MONTICELLO NUCLEAR GENERATING PLANT
 Docket No. 50-263 License No. DPR-22

Supplemental Information on EOC Transient
 Analysis Requested in October 18, 1973 Letter

FIGURE I
 Simplified Arrangement of MSIV
 Position Switches in Reactor Protection System

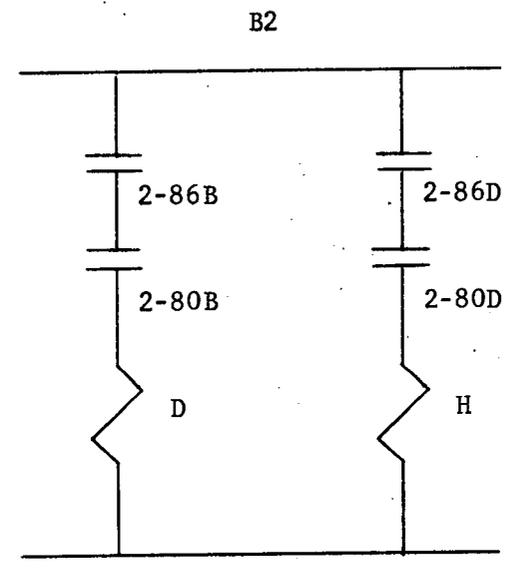
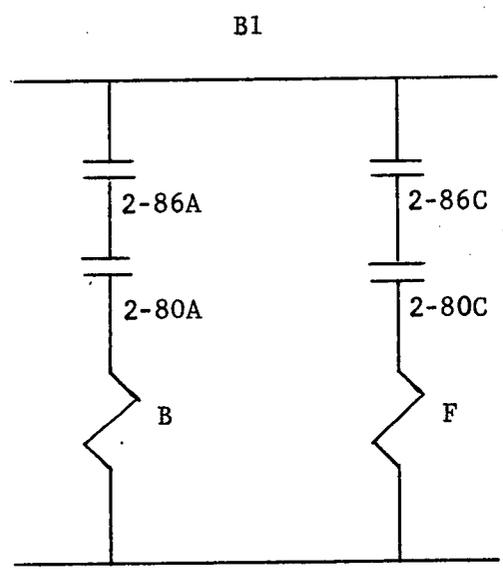
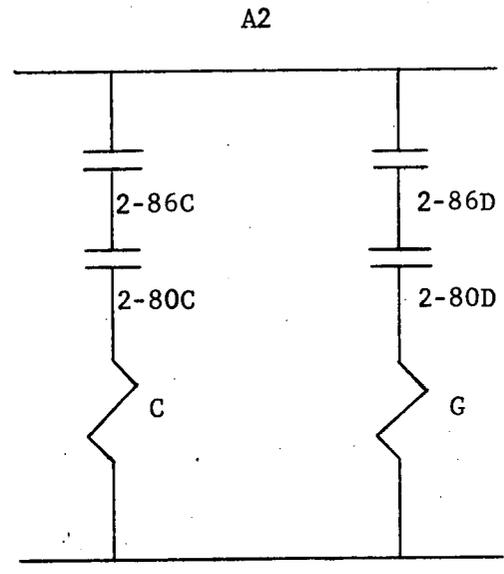
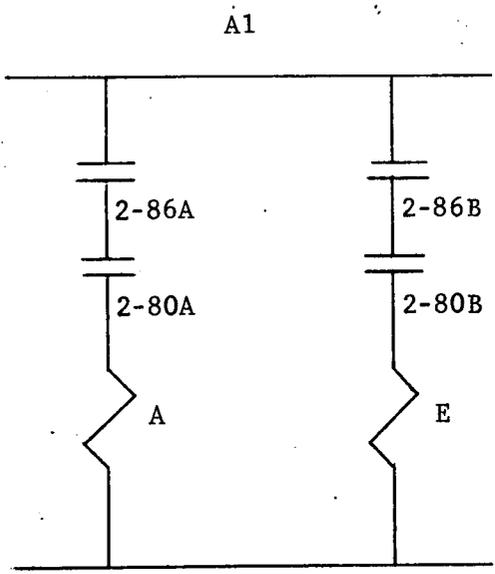
The reactor protection system is a one out of two taken twice logic. A scram occurs on de-energization of the (A1 or A2) and (B1 or B2) subchannels. Failure to scram therefore occurs when the (A1 and A2) or (B1 and B2) channels remain energized. The attached Figure 1 shows in simplified form, the arrangement of MSIV position switches in the scram logic. The 2-80 A through D and 2-86 A through D switches are the inboard and outboard MSIV position switches, respectively, for the four main steam lines. Through additional curcuitry, the A1 subchannel is said to be energized when either the A or E relay is energized and so forth.

Suppose the failure to scram involves failures causing the A1 and A2 subchannels to remain energized during an MSIV closure. This would require the (A or E) and (C or G) relays to remain energized. For the A relay to remain energized, both position switches 2-86A and 2-80A must fail to open as designed. Likewise, for the C relay to remain energized, switches 2-86C and 2-80C must fail to open. Failure of the direct scram in the MSIV closure event can therefore occur only when specific combinations of four or more of the eight valve position switches fail in either the A or B channel; a very unlikely situation.
